Project	IEEE 802.16 Broadband Wireless Access Working Group < <a href="http://ieee802.org/16">http://ieee802.org/16</a> >	
Title	Proposed AWD Text on the Ranging Configurations for Non-synchronized AMSs	
Date Submitted	2008-04-27	
Source(s)	HyunWoo Lee, Jin Sam Kwak, HanGyu Cho, Young-Hyoun Kwon, Sungho Moon	Voice: +82-31-450-7902 E-mail: <a href="mailto:camille@lge.com">camille@lge.com</a> , <a href="mailto:samji@lge.com">samji@lge.com</a> , <a href="mailto:hgcho@lge.com">hgcho@lge.com</a>
	<b>LG Electronics</b>	
Re:	IEEE 80216m-09/0020, "Call for Contributions on Project 802.16m Amendment Working Document (AWD) Content"  "Comments on AWD 15.3.9 UL-CTRL"	
Abstract	This contribution proposes the text of ranging channel section to be included in the IEEE 802.16m AWD.	
Purpose	To be discussed and adopted by TGM for the IEEE 802.16m AWD	
Notice	<i>This document does not represent the agreed views of the IEEE 802.16 Working Group or any of its subgroups. It represents only the views of the participants listed in the "Source(s)" field above. It is offered as a basis for discussion. It is not binding on the contributor(s), who reserve(s) the right to add, amend or withdraw material conta

Figure xxx. The example of ranging channel allocation in time domain for FDD and TDD duplex mode, respectively.

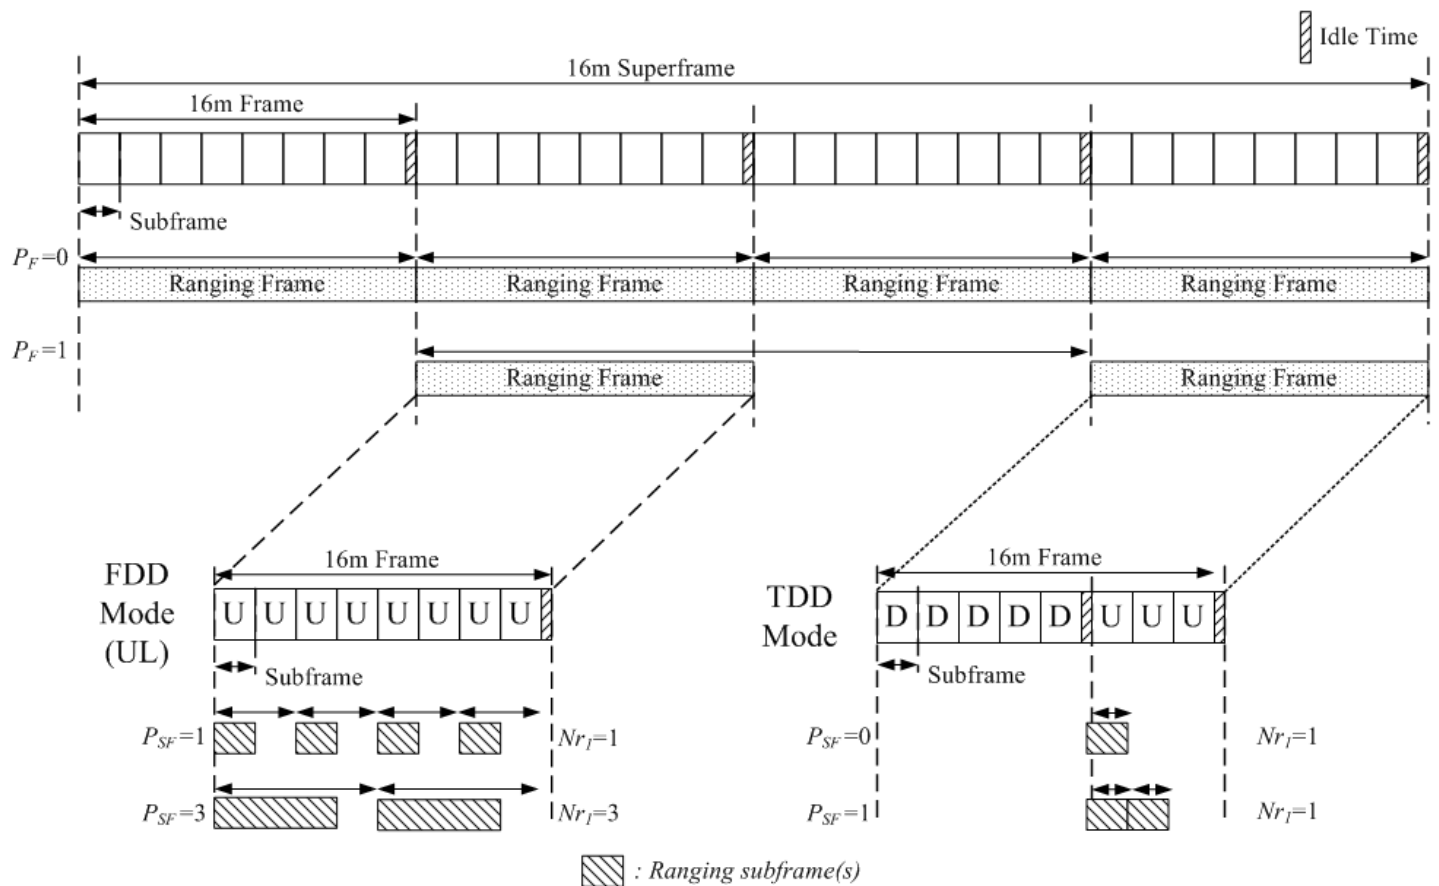
The information for ranging time/frequency resource allocation is indicated by the S-SFH. The the ranging configuration information in the SFH consists of the frame-period ( $P_F$ ) and subframe-period ( $P_{SF}$ ) for ranging time resource allocation, and the starting subband position ( $k_\rho$ ) in the frequency domain as units of subband for ranging frequency allocation. Within a superframe, the ranging channels are allocated from the  $P_F^{\text{th}}$  frame in every frame ( $P_F=0$ ) or every odd frame ( $P_F=1$ ). Within the allocated frame, the ranging channels are allocated from the first UL subframe with period of  $P_{SF}$  in the FDD mode. In the TDD mode, the ranging channels are allocated in the consecutive  $P_{SF}$  subframes from the first UL subframe.

The occupied resource for a ranging channel is defined as  $Nr_1$  subframes by  $Nr_2$  subbands. For Format 0, 1, and 2,  $Nr_1 = 1$ . For Format 3,  $Nr_1 = 3$ . The unit of  $Nr_2$  is [1 or 2] subband(s) for all Formats. Figure xxx shows an example of ranging channel allocation.
